**STAFF RECOMMENDATION**  
**106 Lindsley Park Drive**  
**March 15, 2017**

**Application:** New construction - Infill  
**District:** Lockeland Springs-East End Neighborhood Conservation Zoning Overlay  
**Council District:** 06  
**Map and Parcel Number:** 08309044900  
**Applicant:** John Root, rootArch  
**Project Lead:** Melissa Sajid, melissa.sajid@nashville.gov

**Description of Project:** Application is to construct a new single-family residence on a vacant lot.

EAST ELEVATION - 106 LINDSLEY PARK

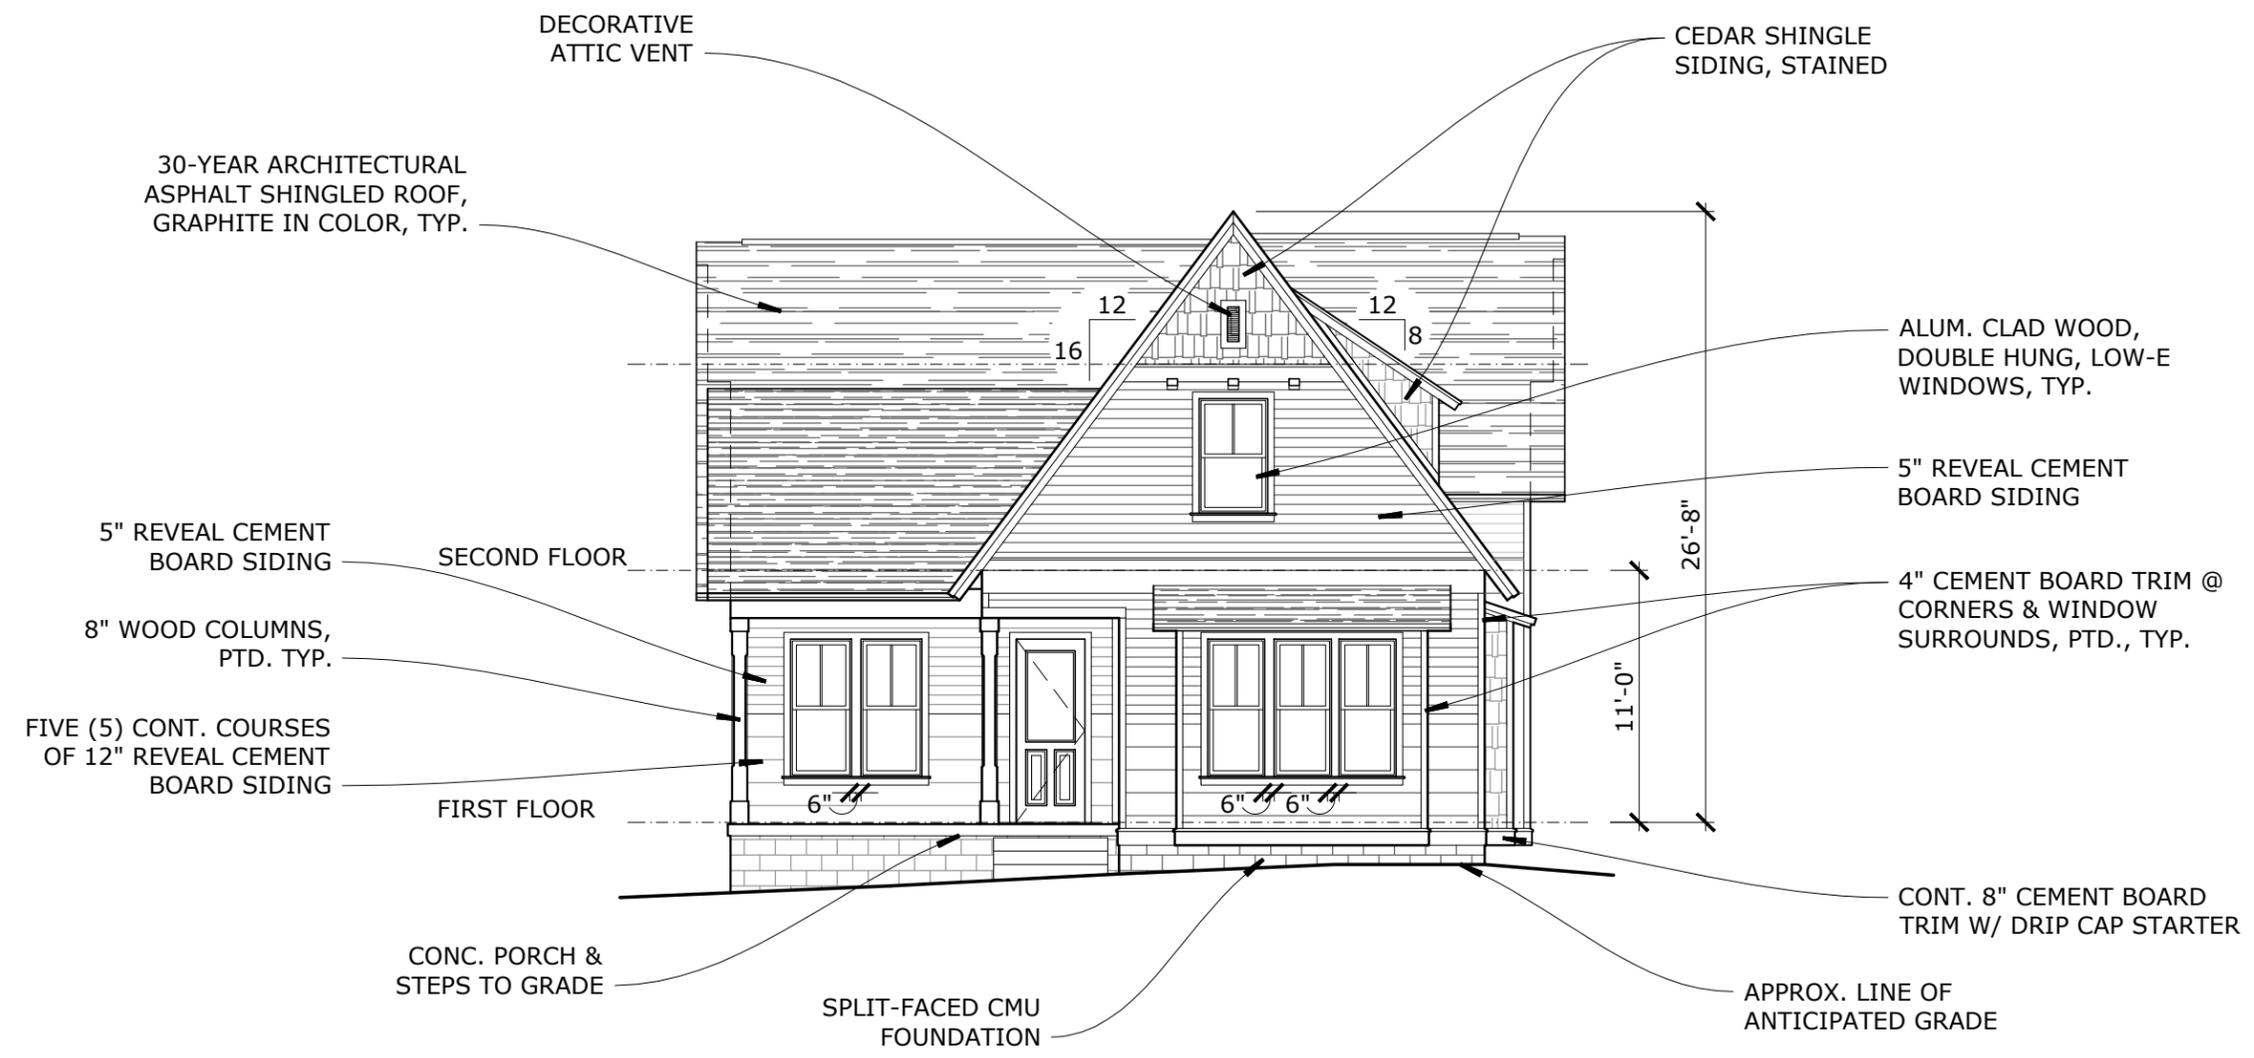
**Height & Scale:** The proposed infill is one and one-half (1.5) stories at the front with an overall height of approximately twenty-eight feet, eight inches (28’-8”) from grade, including a foundation height of approximately two feet (2’) at the front of the building. The overall height of the infill is slightly taller than historic homes on Lindsley Park Drive, which range from sixteen feet to twenty-eight feet (16’-28’) tall. However, staff finds the overall height to be appropriate since the infill will be only eight inches (8”) taller than the historic house across the street at 107 Lindsley Park Drive, and when taking into account the change in grade, the proposed infill will sit lower than that historic house. The infill will have an eave height of approximately twelve feet (12’), which is appropriate for a one and one-half (1.5) story home.

Roof form: The roof will be cross-gabled with pitches of 16:12, 6:12, and 14:12 and includes side and rear dormers with a 8:12 pitch. Staff finds that the roof form and pitches are compatible with the historic context and meet section II.B.1.e.

Orientation: The proposed structure is oriented toward Lindsley Park Drive, with an eight foot (8’) deep partial width front porch that deepens to eleven feet, seven inches (11’-7”) on the left side. The infill includes a walkway that connects to the street. Staff finds this to be consistent with the historic context and that the proposed infill will meet section II.B.1.f.

WEST ELEVATION - 106 LINDSLEY PARK

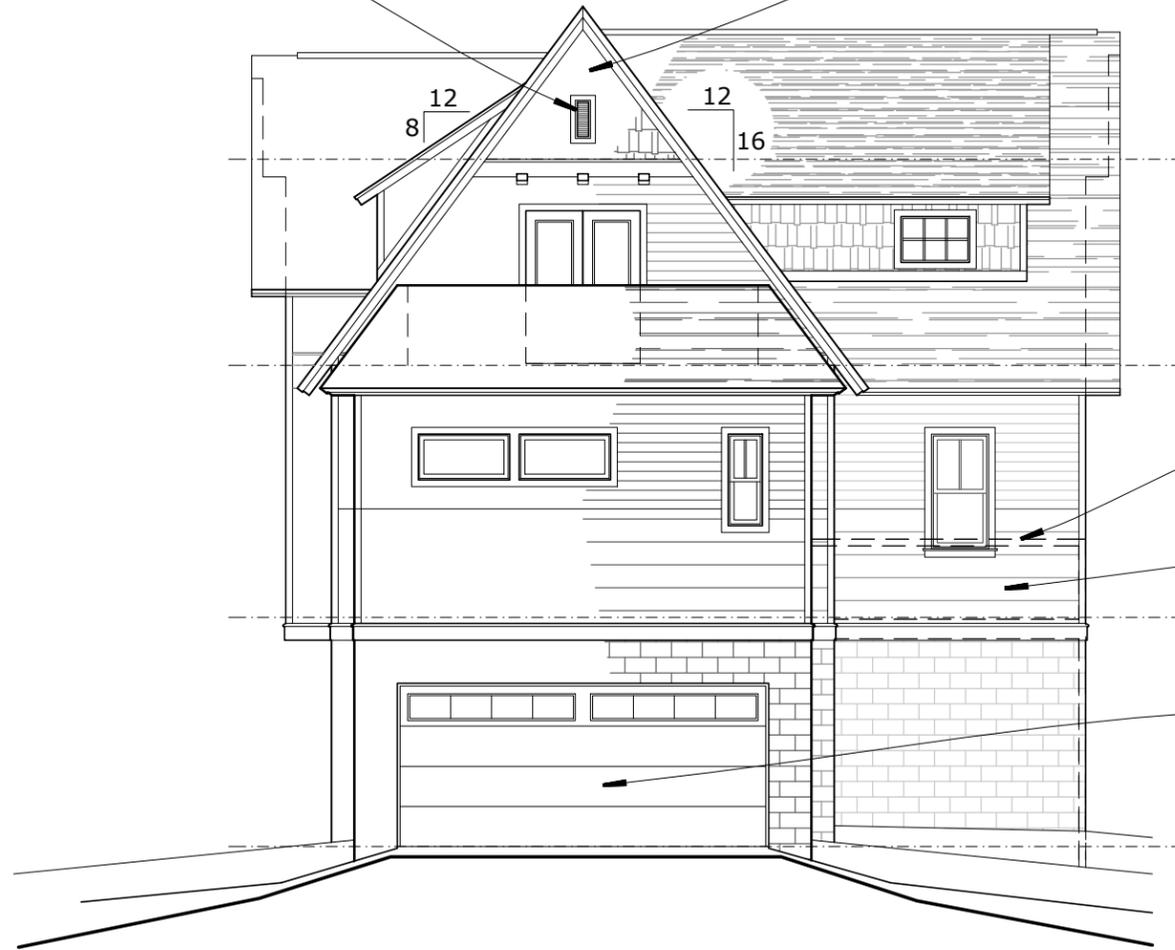
The plan also includes an attached garage that is accessed from a proposed driveway off South Fifteenth Street at the rear. The attached garage is located at basement level and the vehicular access is on the rear elevation, which meets the criteria for when attached garages may be appropriate.

Proportion and Rhythm of Openings: Most of the windows on the proposed infill are generally twice as tall as they are wide, thereby meeting the historic proportions of openings. The plan does include several smaller horizontal windows on the rear and right side façade. Staff, however, finds that these windows could be appropriate given their locations and the change in grade on site as they will not likely be visible from the street. There are no large expanses of wall space without a window or door opening. Staff finds the project’s proportion and rhythm of openings to meet Section II.B.1.g.

NORTH ELEVATION - 106 LINDSLEY PARK

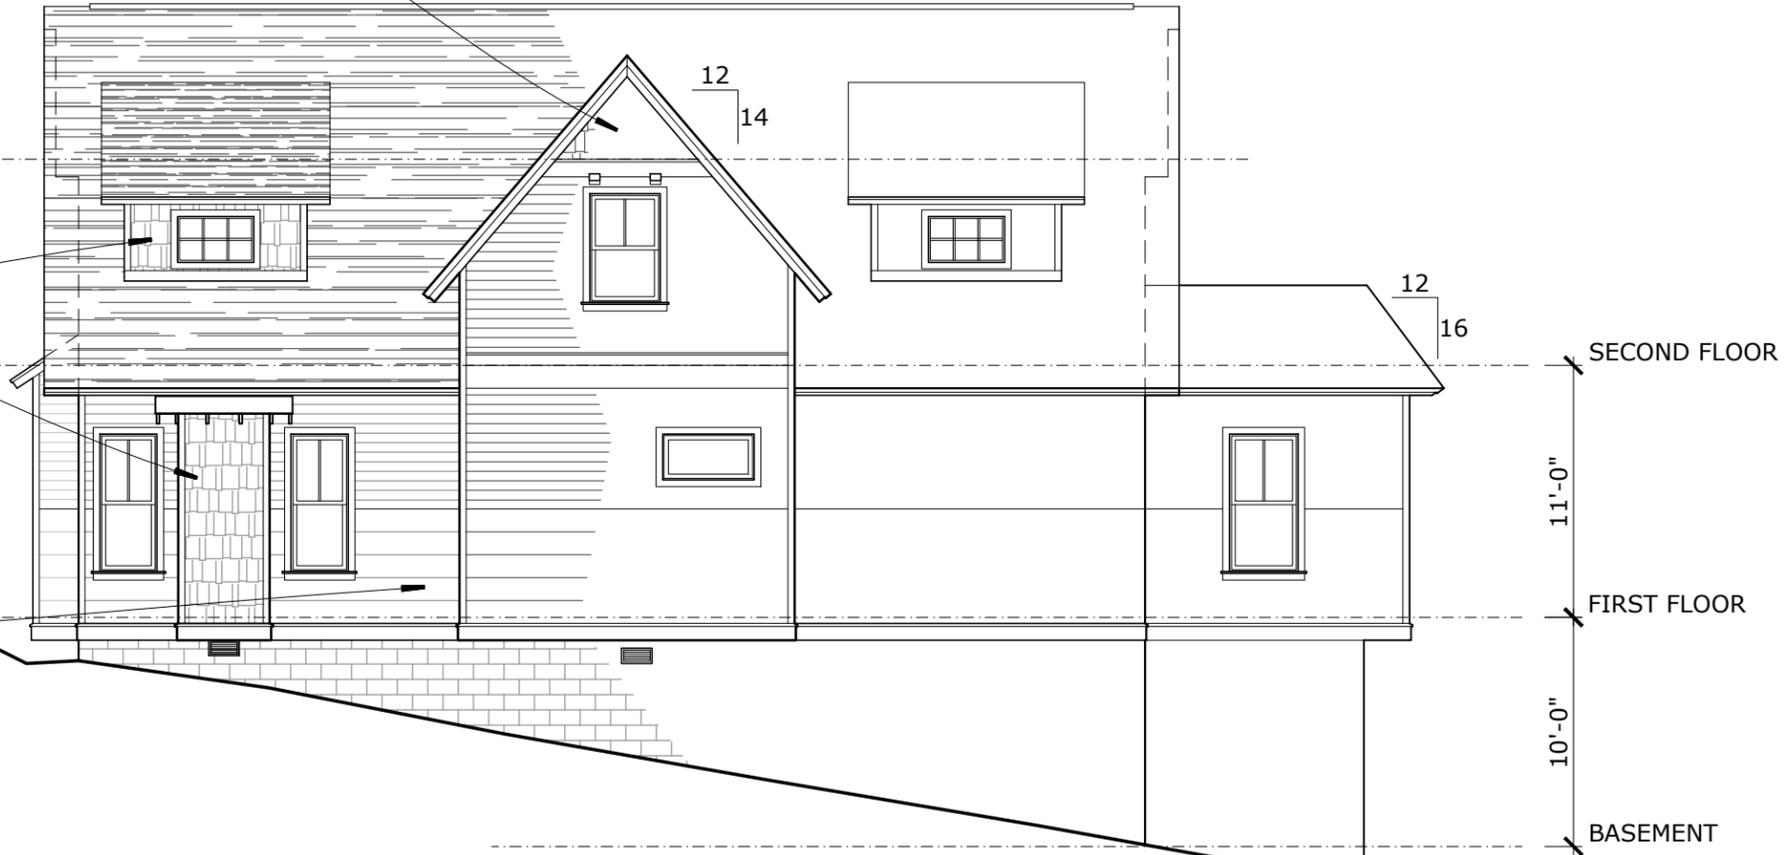
The infill will have a split-faced CMU foundation, cement board siding with a cedar shingle accent, and an asphalt shingle roof. The reveal of the siding will be primarily five inches (5”) as required by the design guidelines but will also include an accent of five (5) courses of twelve inch (12”) reveal which is less than one level, which the Commission has approved in this neighborhood previously. The finish for the siding and trim is not noted, so staff recommends a condition that the siding and trim have a smooth finish. With the condition that staff review the windows, doors, garage doors, driveway and walkway material prior to purchase and installation and that the finish on all siding and trim be smooth, staff finds that the project meets section II.B.1.d.
